## Agenda Report

### REPORT TO DEVELOPMENT REVIEW HEARING

Public Hearing: Action on an Architectural Review (PLN25-00295) for a 621 Square Foot First Floor Addition and a 397 Square Foot Second Floor Addition to an Existing Two-Story 2,081 Square Foot Single-Family Residence with a 500 Square Foot Attached Garage on a 7,351 Square Foot Lot at 2892 Mesquite Drive. CEQA Status: Exempt from CEQA per Section 15332.

**File No.:** PLN25-00295

**PROPOSED ELEVATIONS**

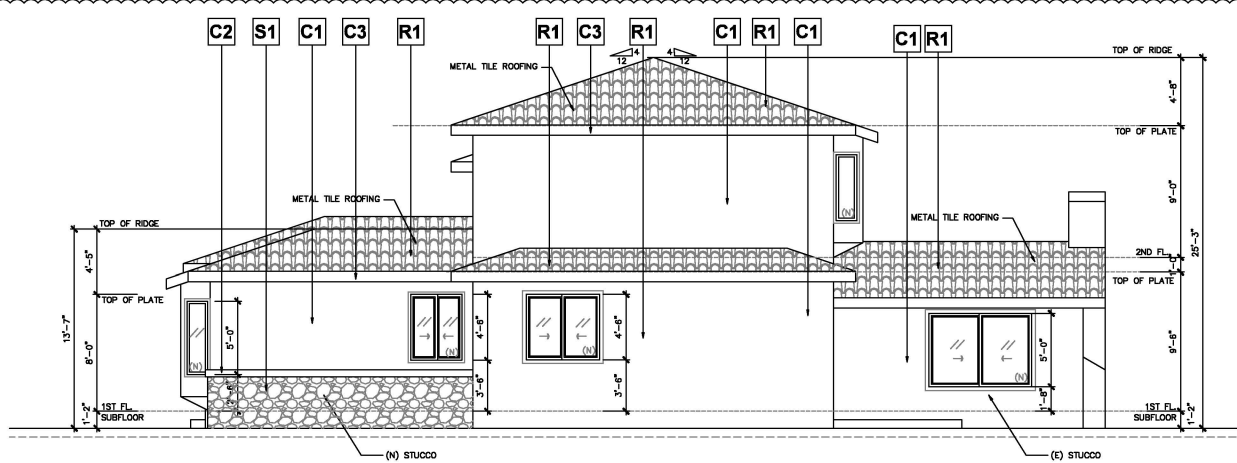
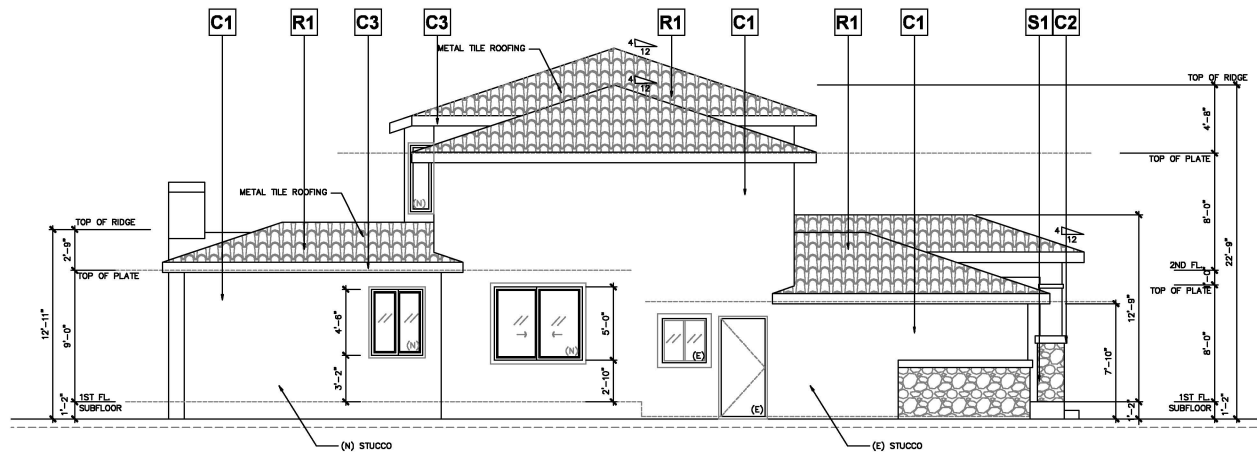
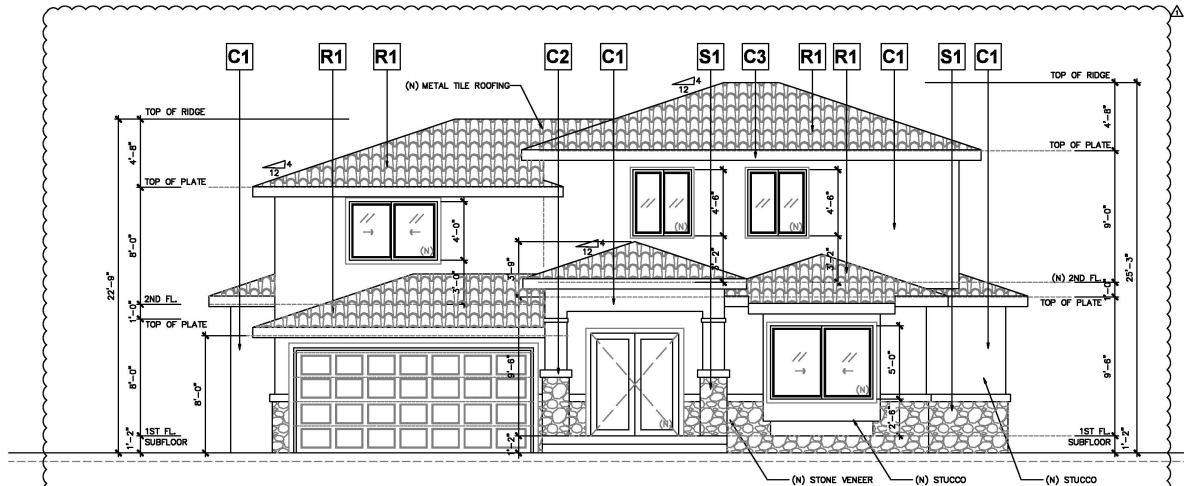
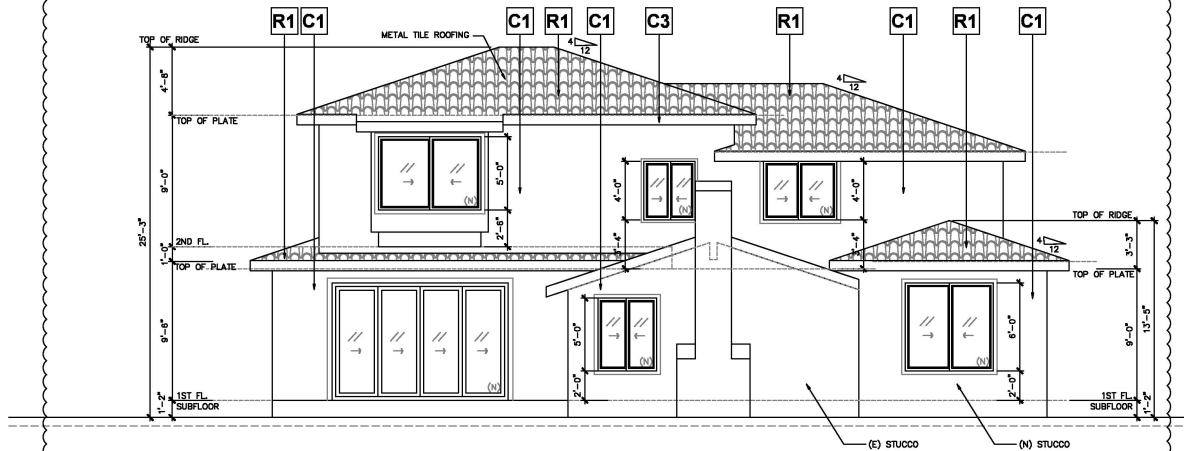
- The entry feature's height as proposed is higher than the rest of the first floor roof line. Staff recommends that the height of the entry feature be reduced to match the rest of the first floor or be below it. This recommendation will be added as a Condition of Approval.

- The design went through multiple revision to ensure compliance with the SCCC and the Residential Guidelines. The roof form was simplified through the removal of a gable element by the front bay window, wainscoting was added on the front elevation, and the entry feature's size & height was reduced.

- P1. **Tree Protection (On-site).** Trees on-site shall be protected from construction activity through ISA tree care best practices.
- P2. **Roof Height.** The roof shall be 25 feet as required by the R1-6L zoning code.
- P3. **Entry Feature's Height.** The Entry Feature's height shall be less than or at the same height as the rest of the first floor's eaves.
